Telecommunications and Coastal Permits for AT&T Wireless Telecommunication Sites

Response to Comments and Questions Raised by the City Council and the Public at the Meeting of August 15, 2017 and in Subsequent Correspondence

Figure 1 - Figure 1 shows the location of these 16 proposed nodes relative to existing AT&T antenna facilities within the City as well as commercially-zoned properties:

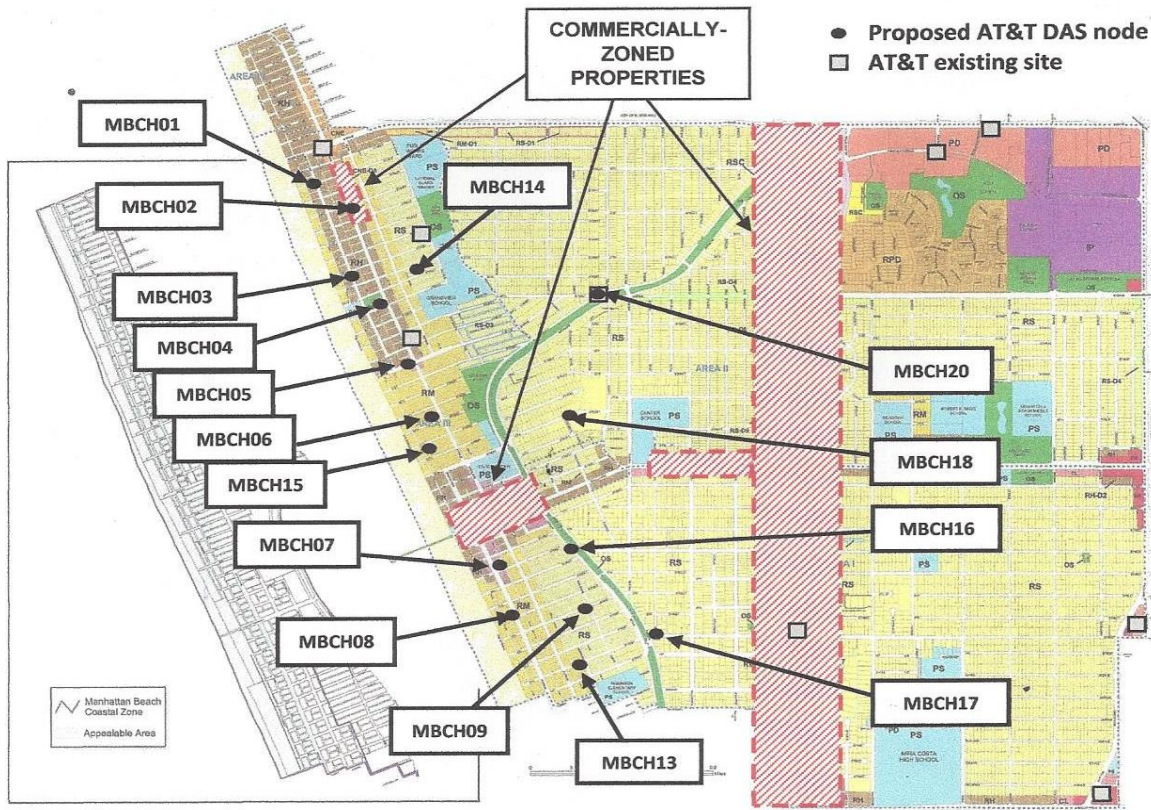
1. Explain why/how the locations for sites have been chosen.

As can be seen in Figure 1 above, the existing AT&T Mobility macro antenna facilities are too far to the east to be modified to serve the beach area and the commercially-zoned properties along Sepulveda Boulevard are also too far to the east to be useful as antenna facilities. It is for this reason that the small-scaled DAS project was selected as a good solution to provide service to this critical beach area of the City. Figure 2 shows the existing AT&T coverage and Figure 3 shows the proposed AT&T coverage under the project.

Figure 4 – Existing Wireless Antenna facilities within the City of Manhattan Beach

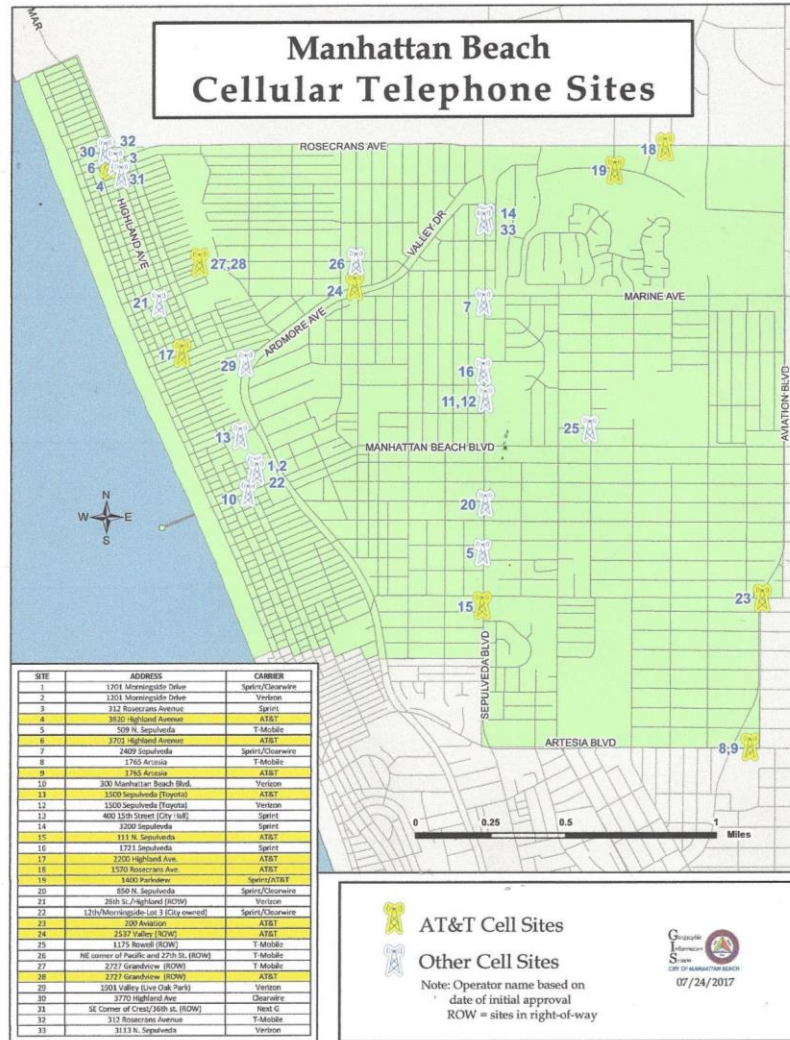
3) Where are the other carriers' telecommunication sites located and can they be collocated?

Figure 4 below shows the locations of the currently operating wireless facilities within the City and their type (building, tower, etc.) as provided by City Planning staff. The target service areas for the proposed projects and the commercially-zoned properties within the City are shown in Figure 5 below to illustrate the proximity of the existing antenna facilities to the intended service area.

Figure 5 - Map of beach target service area and nearest commercial districts with existing cell sites to show how they will not work to cover the service area

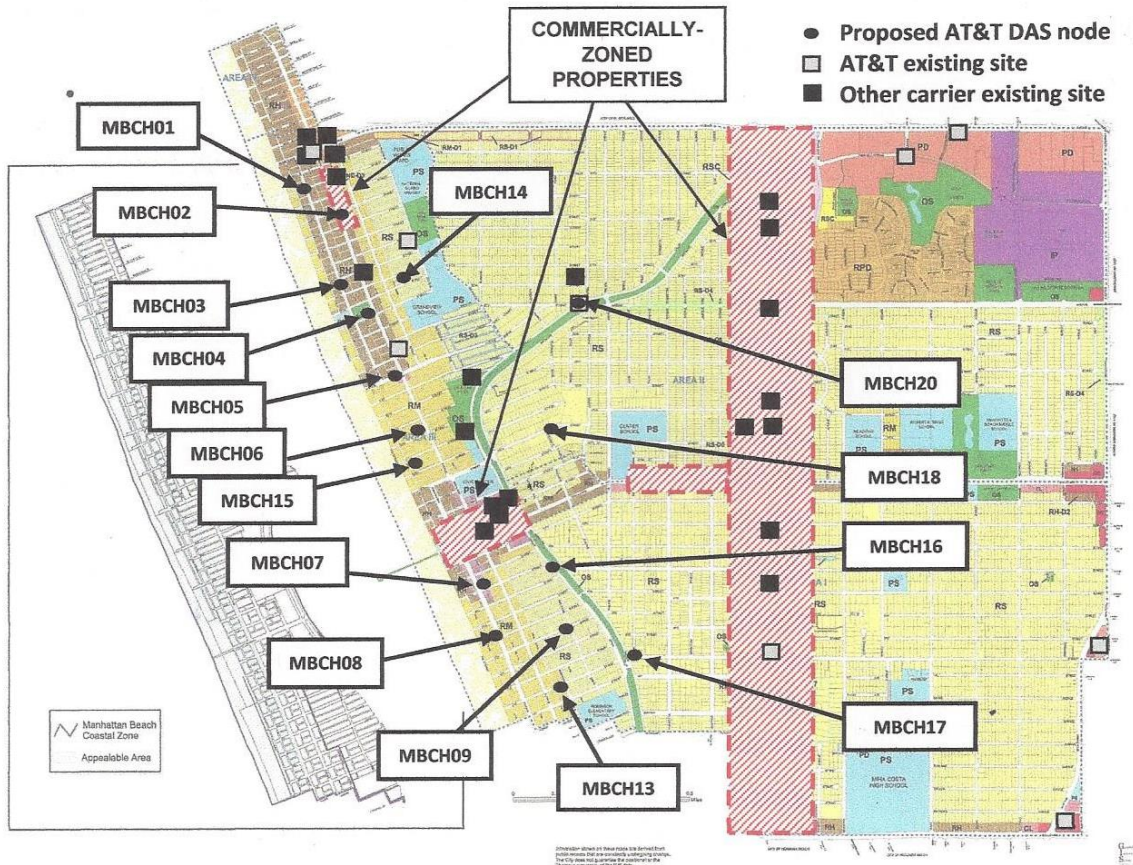
7. Can antennas be attached to existing commercial buildings?

The lack of adequate AT&T signal coverage in the City’s beach district generally west of Valley Drive was previously documented above. As shown in Figure 5, the beach area to be served is entirely residential and the closest commercial buildings are 0.75 to 1.25 miles away inland. Also, as previously noted, the target area, the beach portion of the City, has a varied, hilly topography that cannot be served by existing macro antenna facilities within the City.

The commercially-zoned properties are too far inland and the signals from existing macro antenna facilities within the City cannot be extended or changed to serve the target area.

Specifically, as shown in Figure 5 above, the beach area to be served is entirely residential and the closest commercial buildings are 0.75 to 1.25 miles away inland. As previously noted, the target area, the beach portion of the City, has a varied, hilly topography. The commercially-zoned properties are too far inland to provide service. Antennae would need to be placed 40-50 feet or higher above the existing commercial buildings in order to clear the surrounding buildings and hilly topography. Installations at such heights are not the least intrusive means to achieve coverage.
